33.2.8.5.1 PSE ~~PI~~ pair-to-pair ~~resistance and~~ current unbalance

PSE PI pair-to-pair resistance/current unbalance

Figure 33- X—PSE unbalance evaluation model

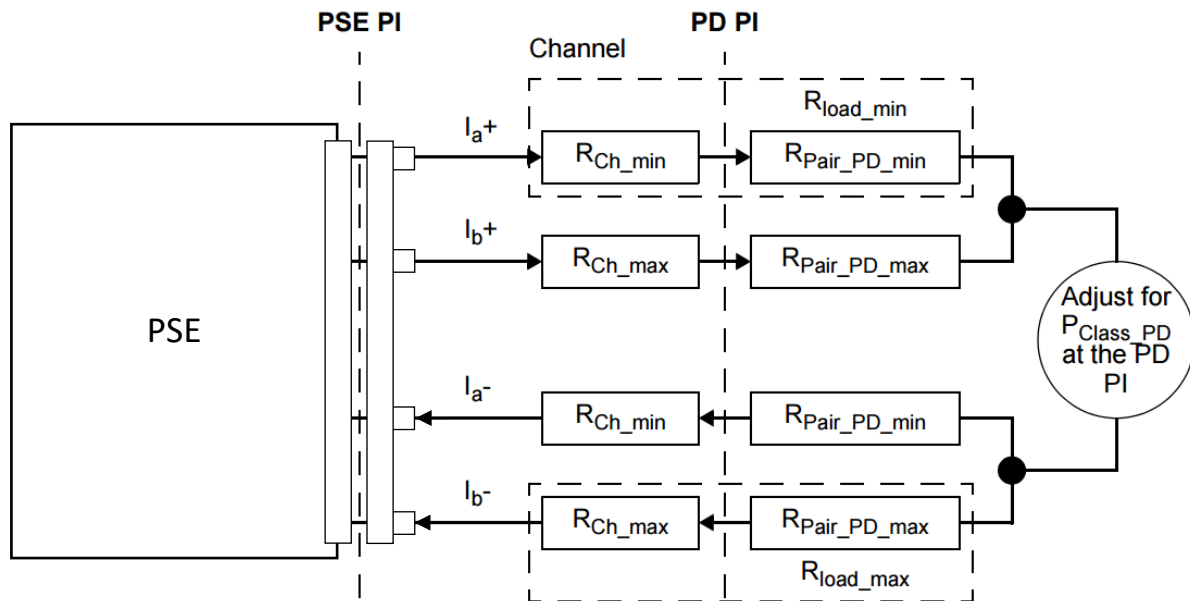
Figure 33-X shows a test circuit for the current unbalance requirements measurement, illustrating the relationship between current unbalance at the PSE ~~PI~~ (I_{a+} , I_{b+} , I_{a-} , I_{b-}), and R_{load_min} and R_{load_max} as specified in Table 33-X.

Current unbalance requirements ($I_{Con-2P-usb}$) of a PSE shall be met with R_{load_max} and R_{load_min} as specified by Table 33-X.

- 1) Use R_{load_min} and R_{load_max} from Table 33–X for R_{load} at low channel resistance conditions.
- 2) With the PSE powered on, adjust the load to P_{Class_PD} at the PD PI.
- 3) Measure I_{a+} , I_{b+} .
- 4) Swap R_{load_max} , R_{load_min} , repeat steps 2 and 3.
- 5) Repeat steps 2 to 4 for I_{a-} , I_{b-} .
- 6) Verify that the current in each case does not exceed $I_{Con-2P-usb}$ minimum in Table 33–18.
- 7) Repeat steps 2 to 6 for R_{load_min} and R_{load_max} from Table 33–X for R_{load} at high channel resistance conditions.

Figure 33B- 1—PSE PI unbalance specification and E2EP2PRunb

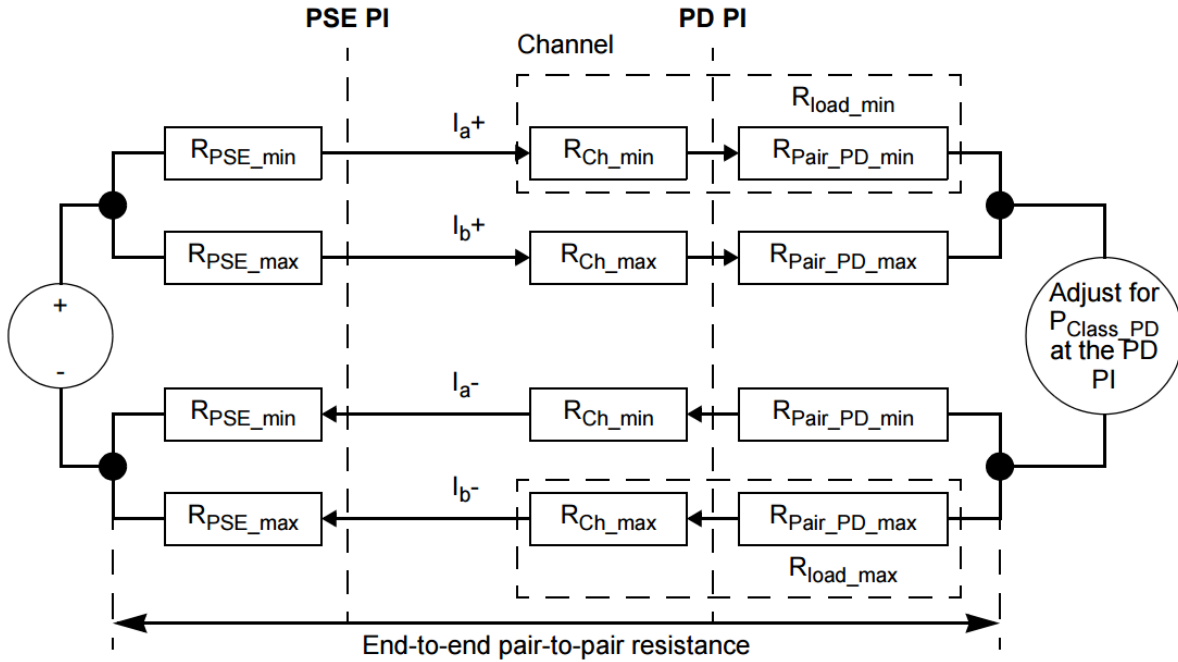
Figure 33B-1 illustrates the relationship between effective resistances at the PSE PI as specified by Equation (33B-15) and R_{load_min} and R_{load_max} as specified in Table 33B-1 end-to-end pair-to-pair resistance.

Figure 33B-4—Current unbalance test circuit

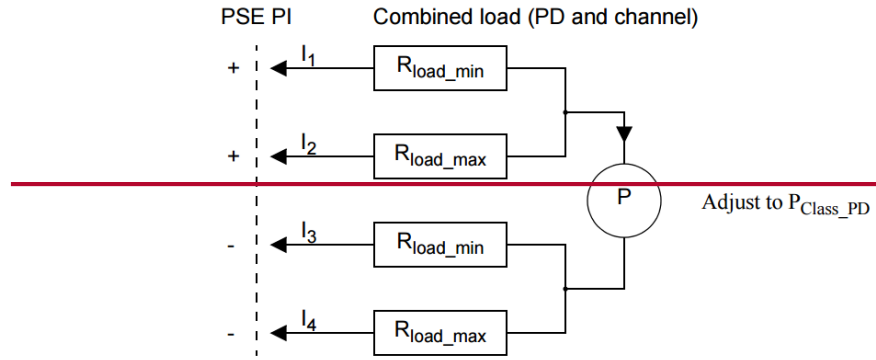
~~The following method may be used if the PSE is using active or passive current balancing circuitry that results in a variable effective resistance to control current unbalance. The current unbalance requirement shall be met for any pairs of the same polarity and with the load resistances per Table 33B-1. A PSE which uses current balancing methods which effectively using lower $R_{\text{PSE-max}}$ than required by Equation (33-15) and meets $I_{\text{Con-ZP-umb}}$ requirements by definition also meets Equation (33-15). Figure 33B-4 shows a test circuit for the current unbalance requirements measurement.~~

- 1) Use R_{load_min} and R_{load_max} from Table 33B-1 for R_{load} at low channel resistance conditions.
- 2) With the PSE powered on, adjust the load to P_{Class_PD} .
- 3) Measure I_1 , I_2 .
- 4) Swap R_{load_max} , R_{load_min} , repeat steps 1 and 2.
- 5) Repeat for I_3 , I_4 .
- 6) Verify that the current in each case does not exceed $I_{Con-zp-unb}$ minimum in Table 33-18.
- 7) Repeat steps 1 to 6 for R_{load_min} and R_{load_max} from Table 33B-1 for R_{load} at high channel resistance conditions.
